Vogle Project

August 1, 1988

PLANT VOGTLE - UNITS 1 & 2
NRC DOCKETS 50-424, 50-425
OPERATING LICENSE NPF-68, CONSTRUCTION PERMIT CPPR-109
FSAR CHANGES FOR RADWASTE FACILITIES

Attached are the proposed changes to the FSAR for the Dry Active Waste (DAW) Facilities, Alternate Radwaste Building (ARB), Control Area modification, and the ARB bridge crane addition. Existing warehouses located on the southwest portion of the owner controlled area are being extensively modified to handle the DAW. A new addition to the ARB will house the ARB Control Room and dress-out area. The existing pedestal crane in the ARB is being replaced by a bridge crane.

FIGURE 1.2.2-1 (SHEET 1 OF 3)

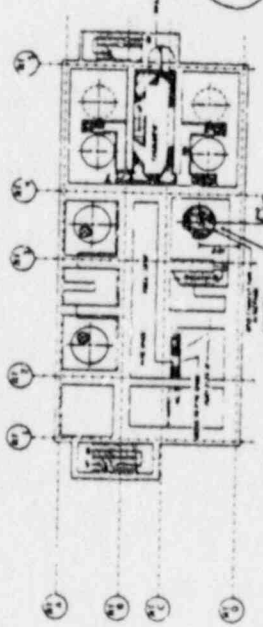
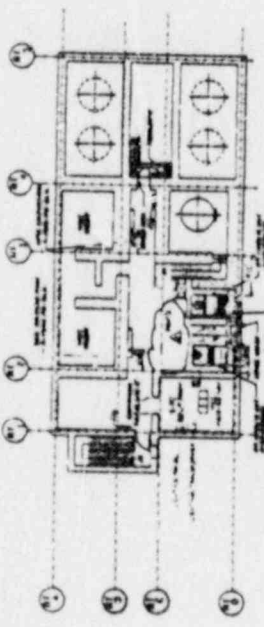
74. Dry Active Waste Processing Building
 75. Dry Active Waste Storage Building

Note: This Figure changed by DCP 88 VLE0061-0-1 and refer to addition of bridge crane next page.

FIGURE 1.2.2-33

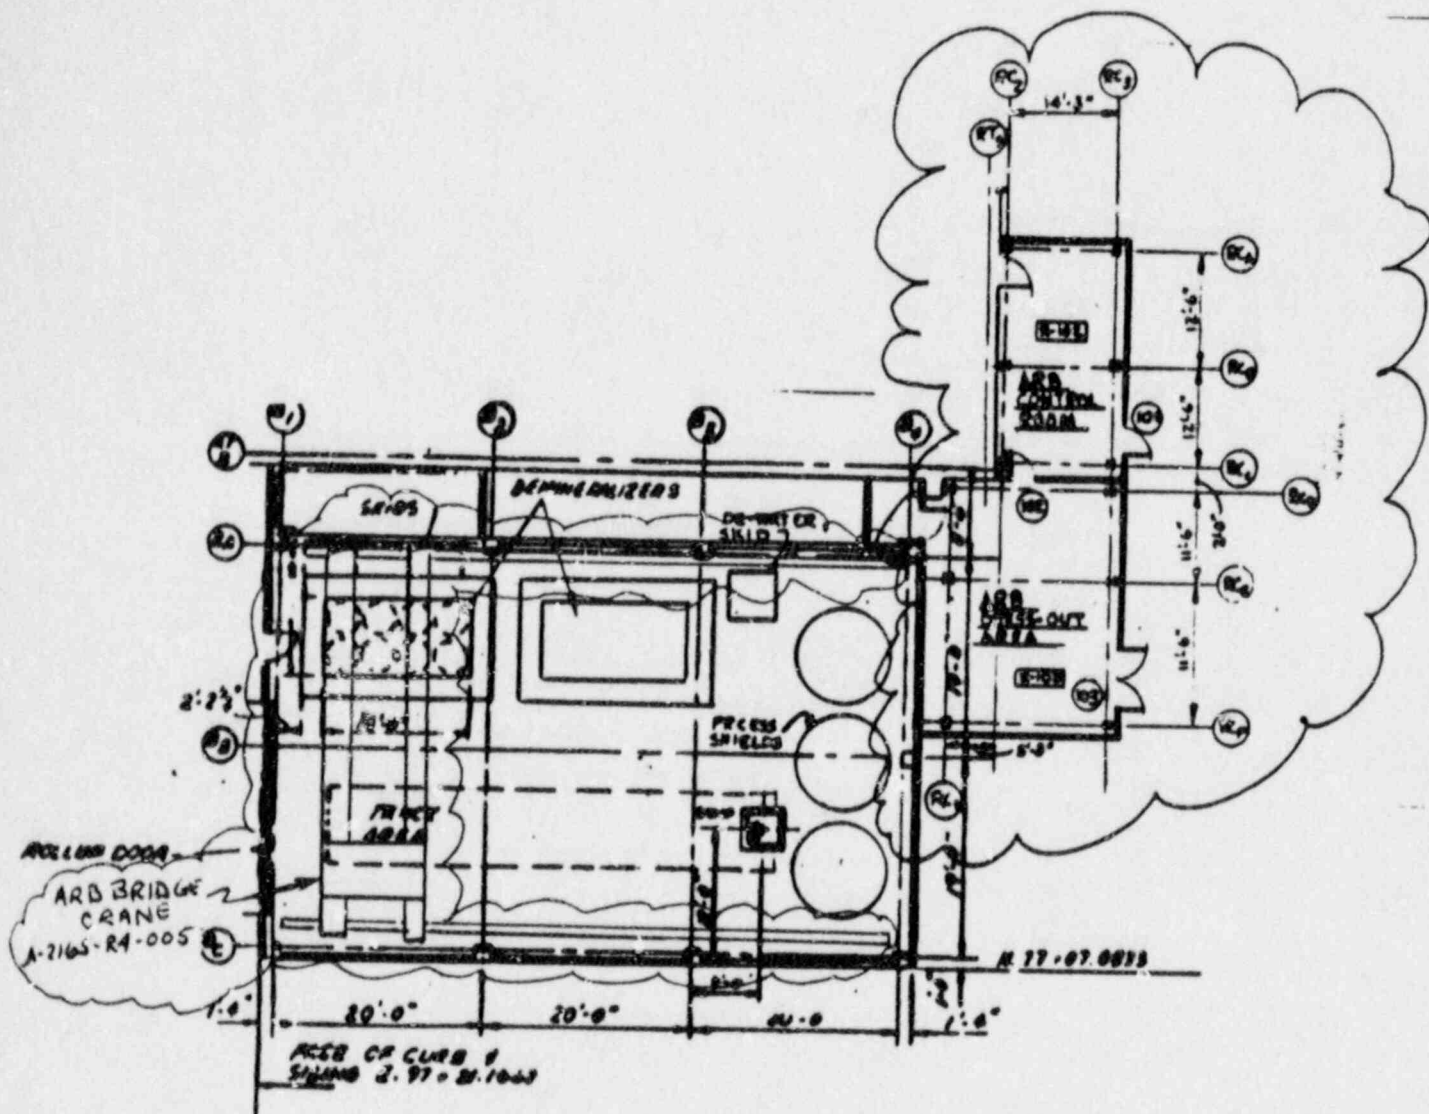
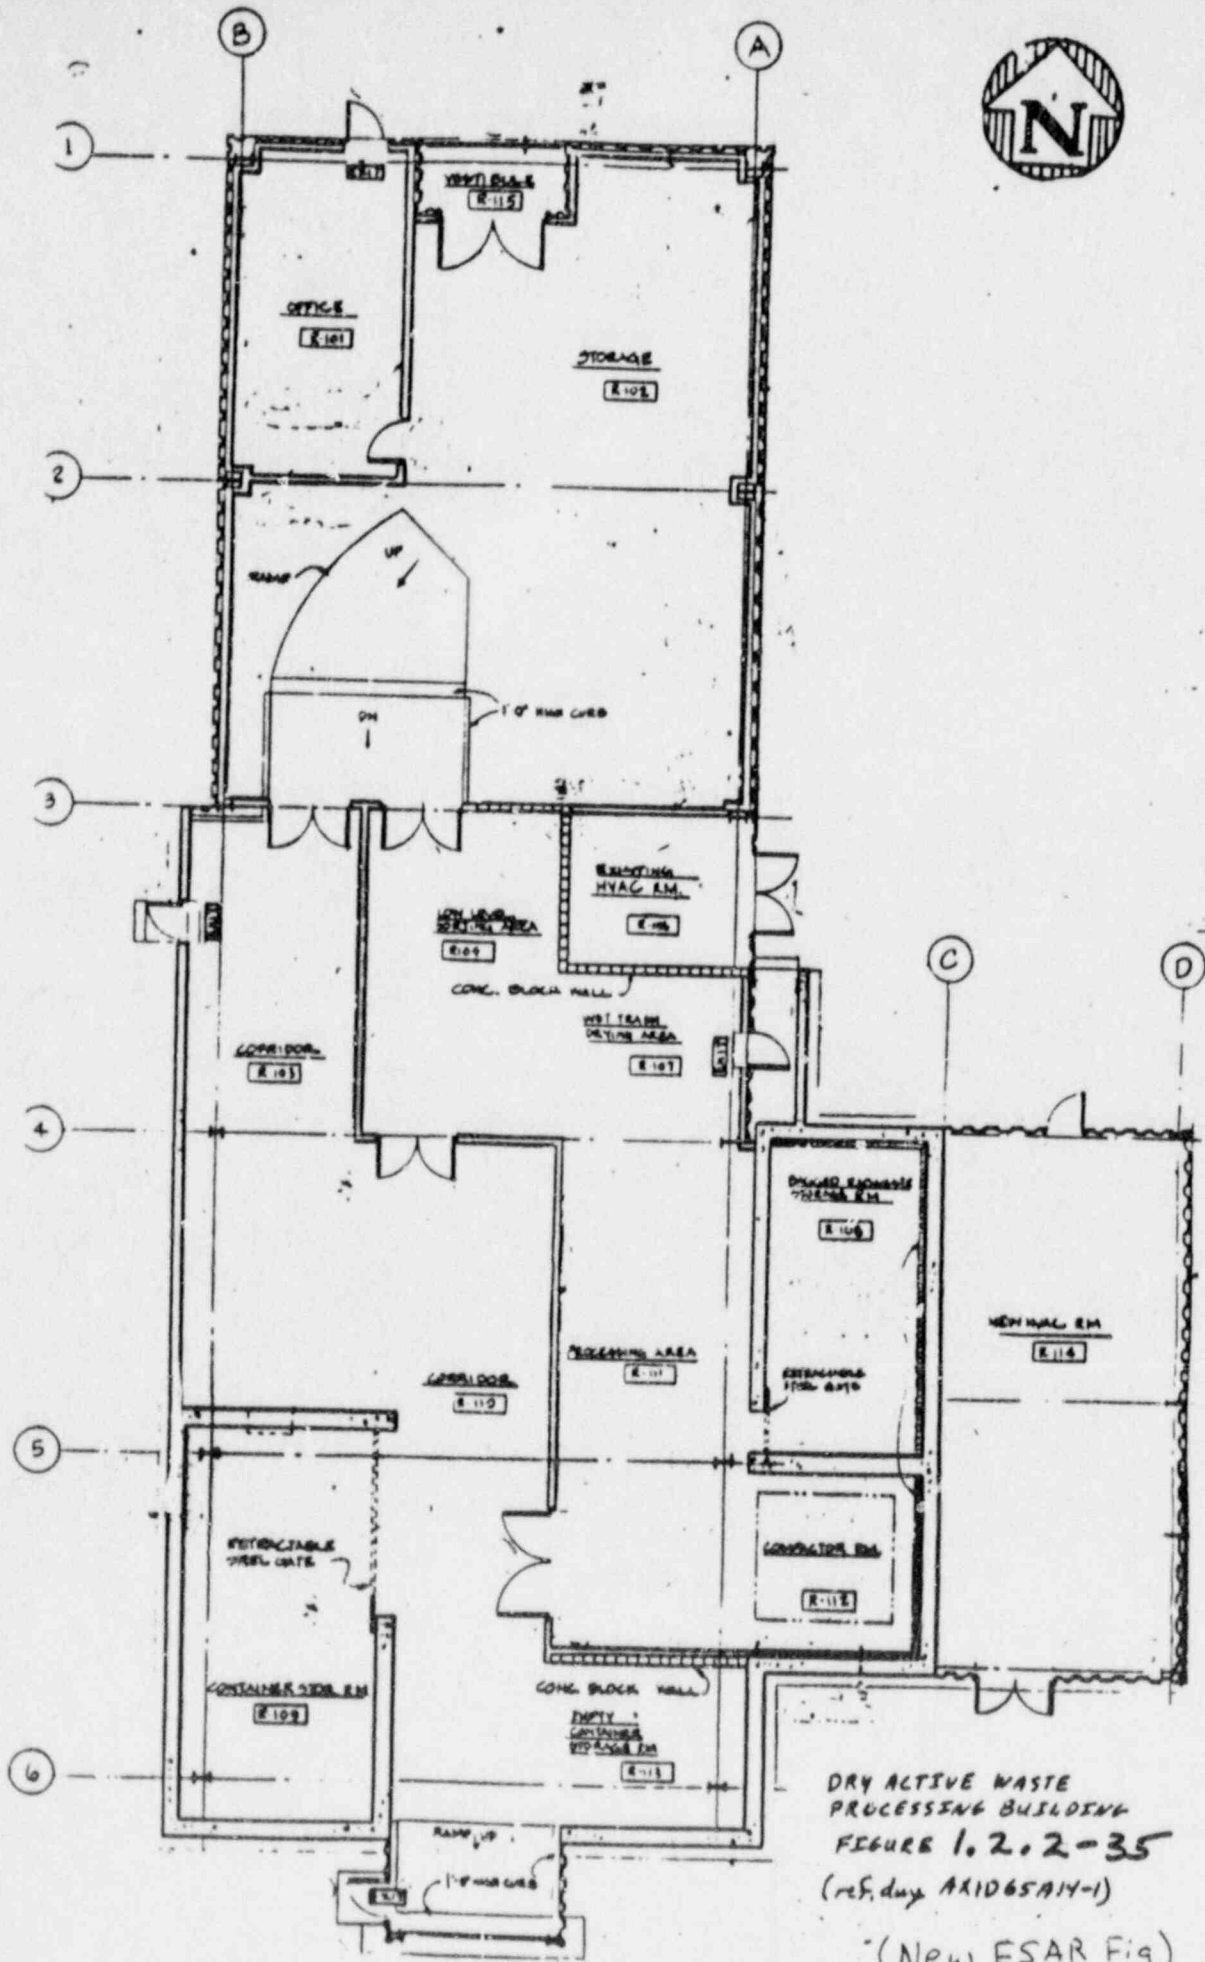
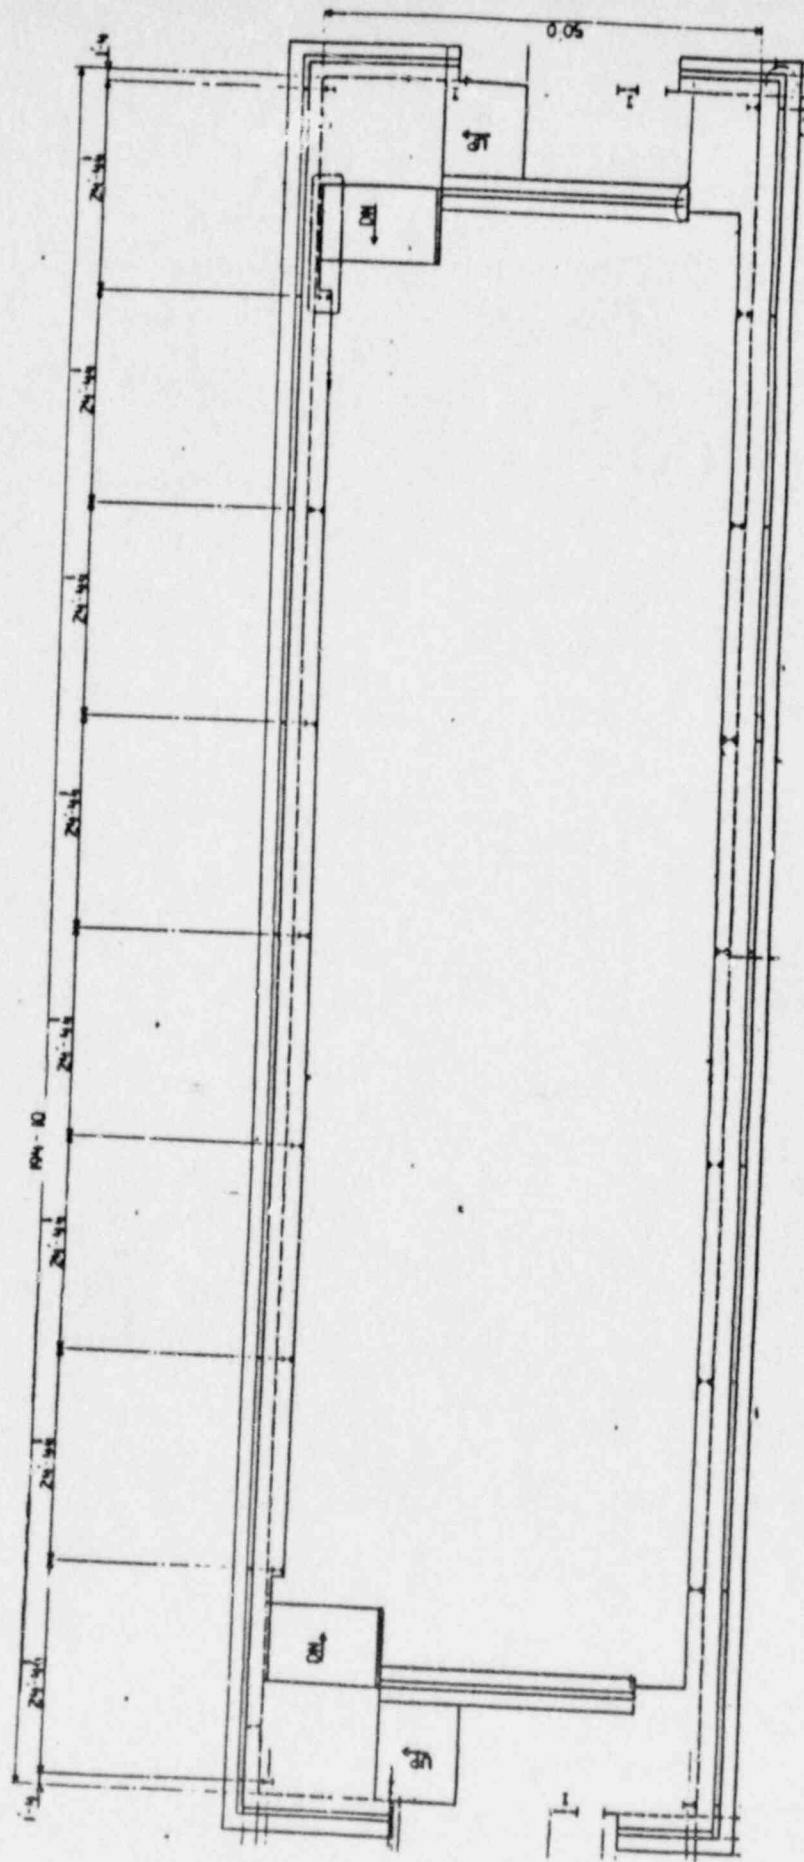
REVISED PORTION OF

ESAR FIGURE 1.2.2-33

Figure 9.1.5-5 (SHEET 42 OF 42)

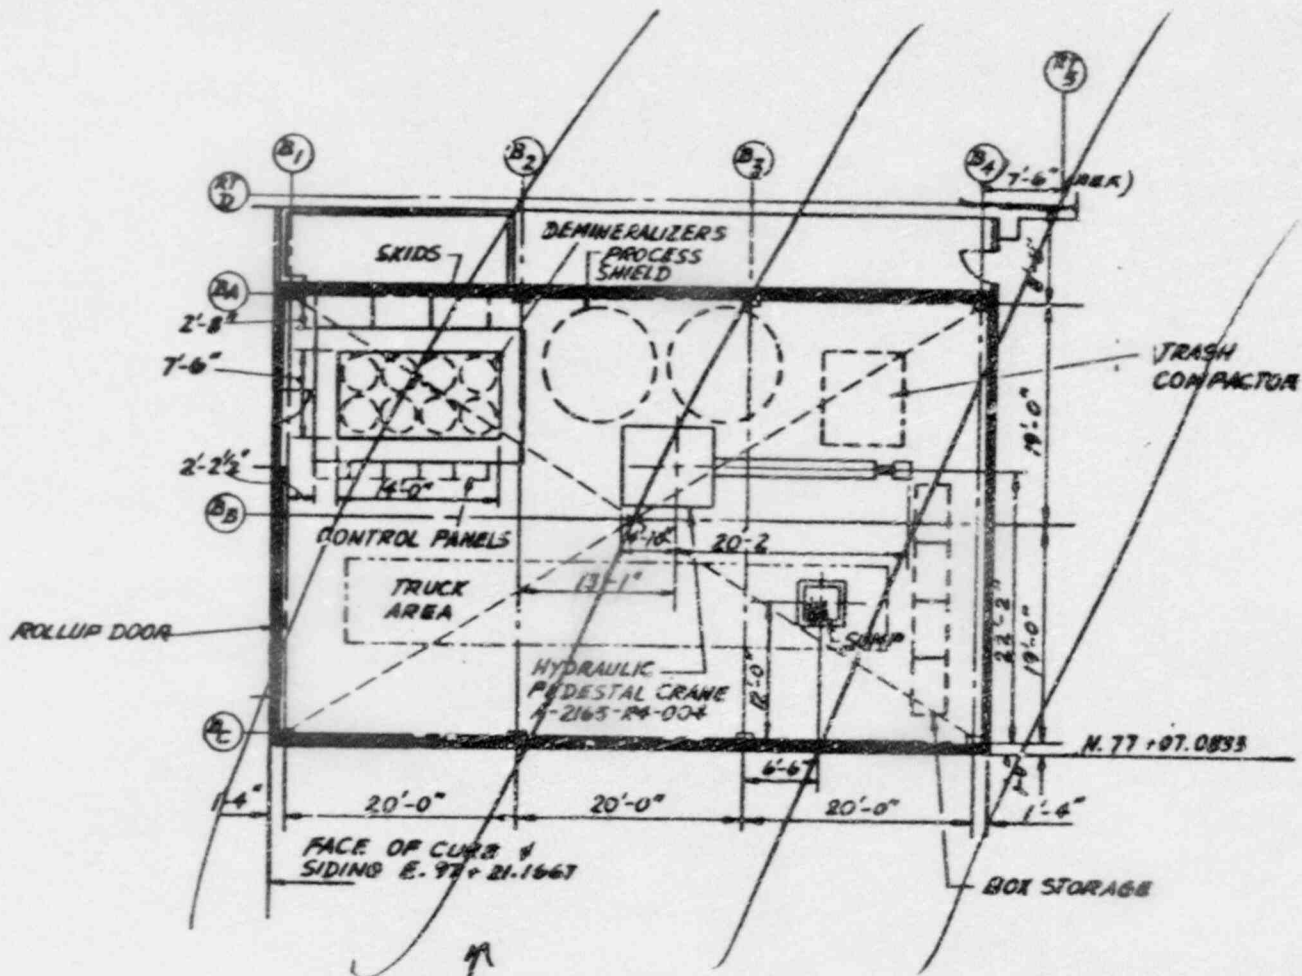
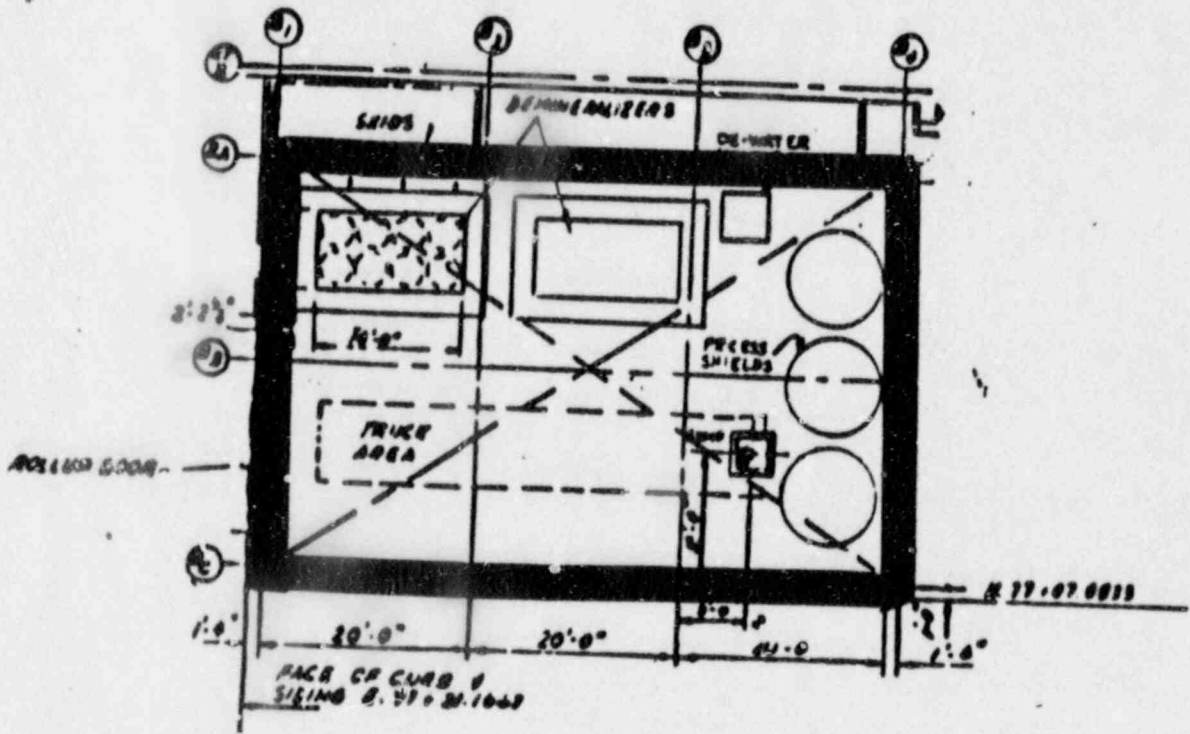
Replace Figure
with next page

~~NOTE:
PEDESTAL CRANE BOOM CAN ACCESS
ALL OPERATING PIPING.~~

Revised Figure 9.1.5-5 (sheet 42 of 42)

FIGURE 9.3.3-3 (SHEET 11 OF 11)

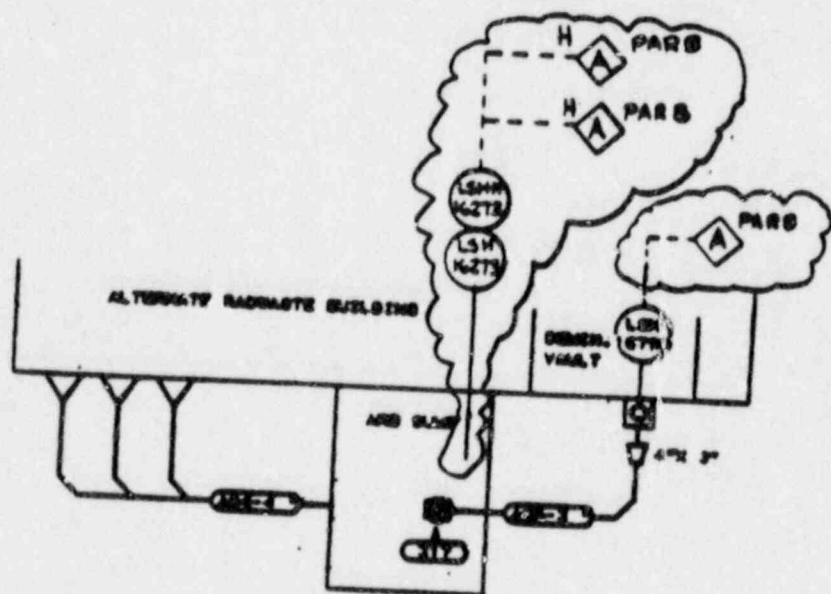
"PROPOSED CHANGES"

FIG 9.3.3-3 (SHEET 11 of 11)
